CITY OF PORTLAND

Permit Number: 090715

This is to certify that Neptune Properties Inc/Sign Design Inc
has permission to Install 8' x 8' Sign on existing pole
AT 1025 Forest Ave EBL 142 C001001

City of Portland, Maine - Building or Use Permit Application

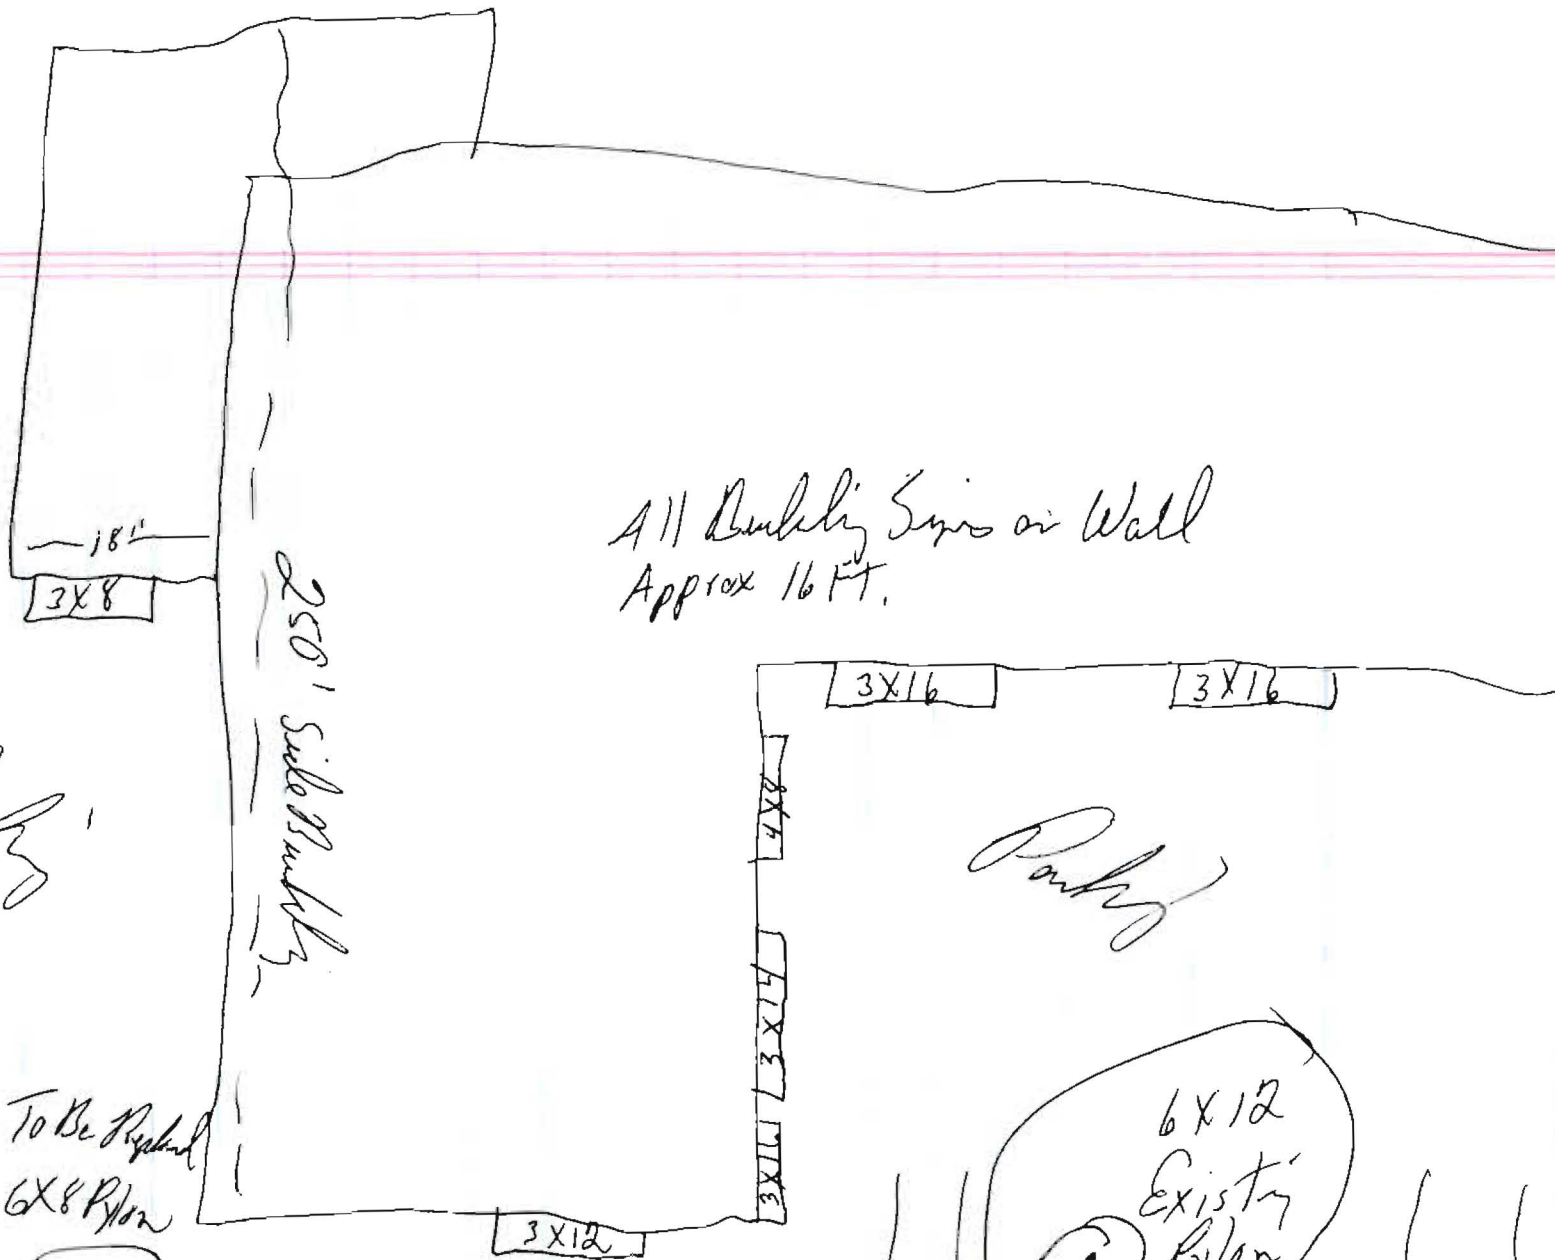
Ann,
We'd like to re-submit 1037, replacing the existing size.

Client: A & M Partners rev. 2
 File: a&m comp. 3
 Date: 7.13.09
 Approval:

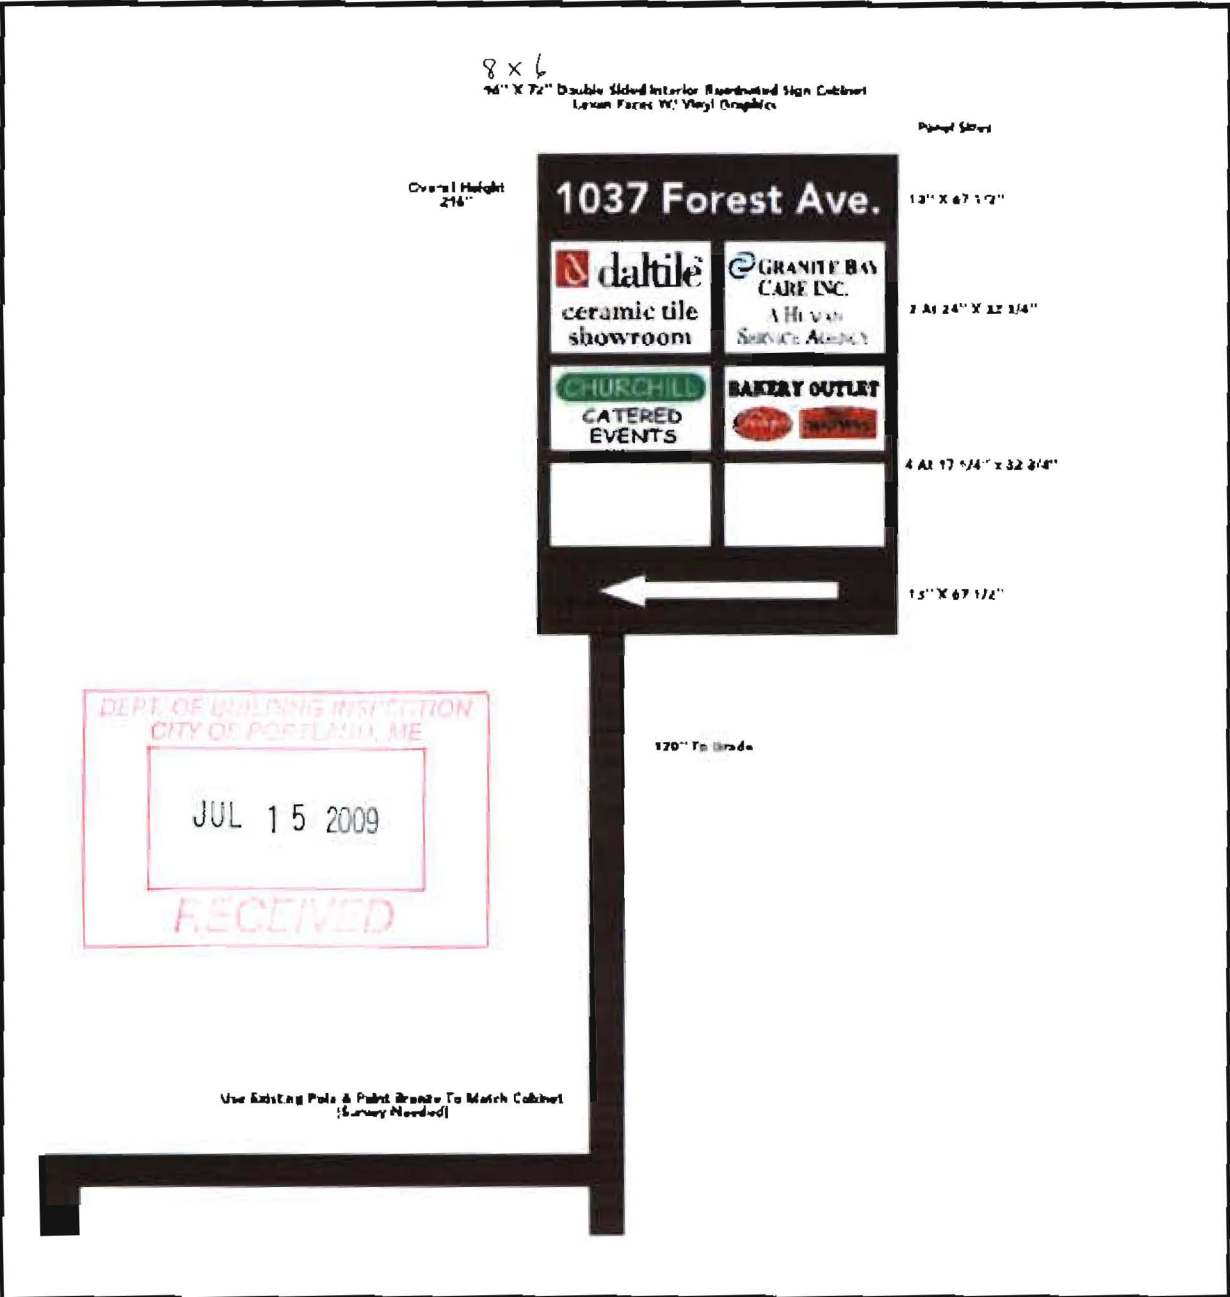
freestanding sign - only allowed one.
6x12 existing - permitted # 95-0118
6x8 existing
revised sign - 6x8 ok

Client: A & M Partners
 File: a&m comp. 3
 Date: 6.24.09
 Approval:

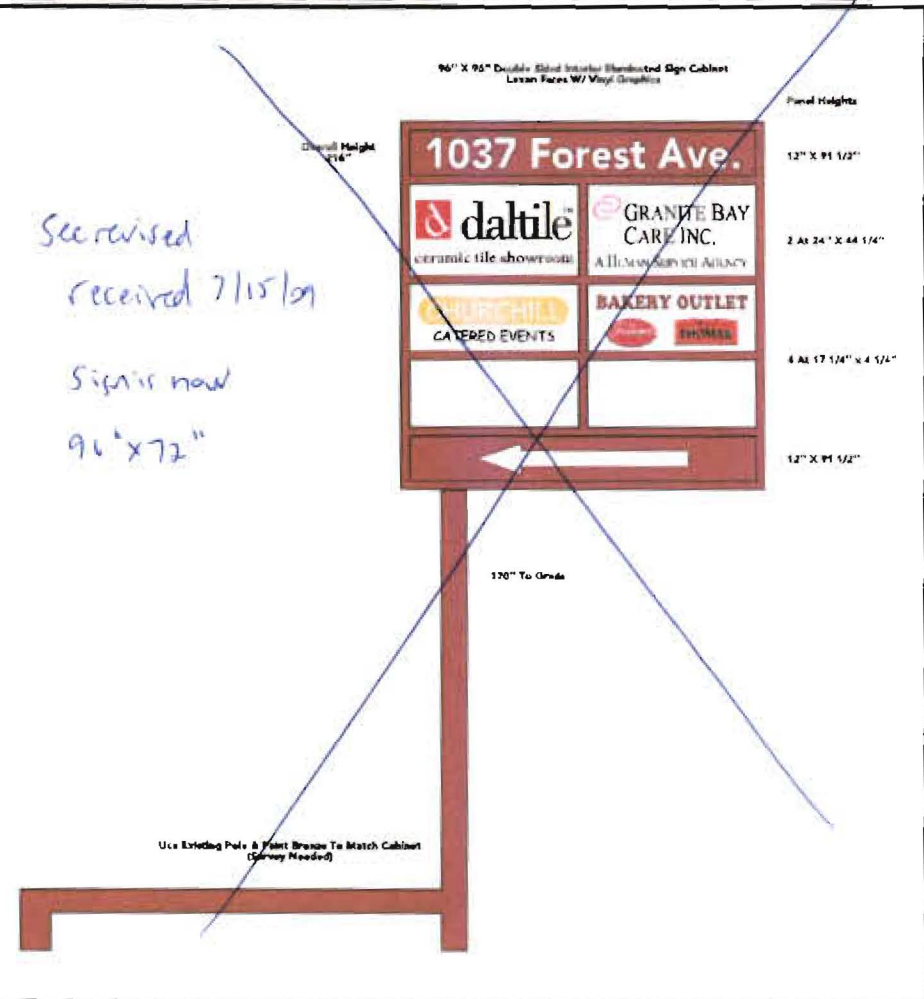
Comments:
7/13/2009-amachado: Property has two freestanding signs. This was approved in 1999 (#95-0118) as a special review by Deb Andresw under section 14-368.5(g). Proposal is to increase the size of the second sign from 6' x 8' to 8' x 8'. Since it is legally nonconforming it can't be increased.
7/15/2009-amachado: Received revised sign drawing. Proposed sign is now 6' x 8'.

See revised
 received 7/15/09
 Sign is now
 96" x 72"
